NOTES AND ERRATA

**POWER PLUG
(LOOKING AT SCREWS)**

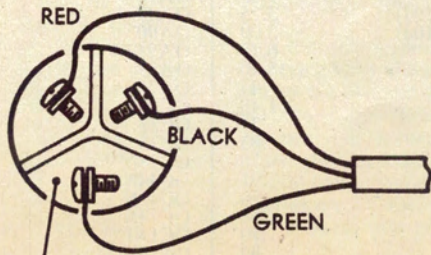
LOW COST STEREO SYSTEM: (January 1972, File No 1 / SA / 38). Several readers have commented on the diagram on page 39, querying the connection of the

active and neutral leads to the three pin plug. Contrary to what some readers apparently believe, there is strictly no regulation requiring that the active, neutral, or earthing conductors be connected to a plug or socket in any specific order. All that exists is a recommendation that the pins be wired in the order earth, active, neutral, in a clockwise direction, when viewed from the front of the socket. In practice, this convention will have been followed in the vast majority of installations. Since the wiring we showed does not conform to it, the black and red leads should be transposed, as shown.
